Model type:
BAAN14X

Commercial code:
F036352

51520h0 Exploded views

N1030093fig1

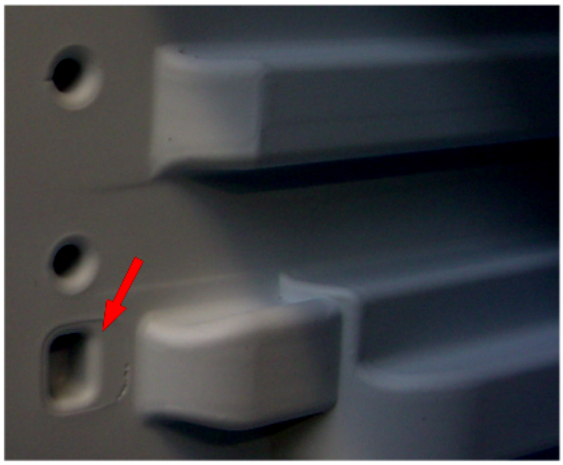
n1030093: New fixing of evaporator on static fridge-freezers (05 range) 60 cm,Melano

From August 05 (serial no. 50802.0001) the freezer evaporator is secured to the cabinet by a plastic profile.
The cabinet walls have been modified to create locations to house the profile, which is installed on the front of each evaporator plate (see photo N1030093fig1- fig2 - fig3)
The profile cannot be fitted on premodification appliances, so technical personnel must continue to fit the rh and lh supports on these models (see photo N1030093fig4)

New parts
C00141135 = WHITE PROFILE L=443.5 MM

Parts replaced
C00075596 = EVAPORATOR RH SUPPORT
C00075597 = EVAPORATOR LH SUPPORT

N1030093fig1

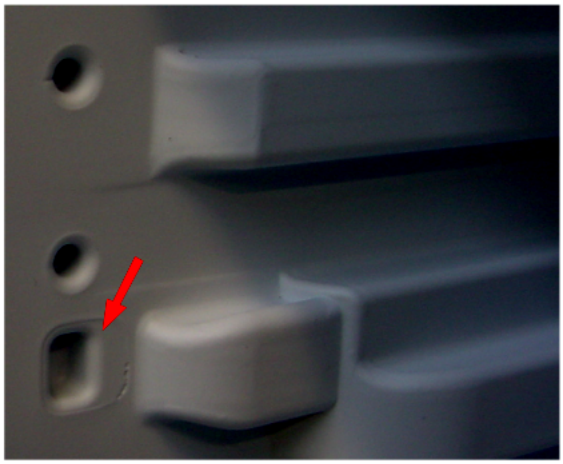
n1030094: New fixing of evaporator on static fridge-freezers (05 range) 60 cm, Lodowek

From August 05 (serial no. 50820.0001) the freezer evaporator is secured to the cabinet by a plastic profile.
The cabinet walls have been modified to create locations to house the profile, which is installed on the front of each evaporator

plate (see photo N1030093fig1- fig2 - fig3)
The profile cannot be fitted on premodification appliances, so technical personnel must continue to fit the rh and lh supports on these models (see photo N1030093fig4)

New parts
C00141135 = WHITE PROFILE L=443.5 MM

Parts replaced
C00075596 = EVAPORATOR RH SUPPORT
C00075597 = EVAPORATOR LH SUPPORT
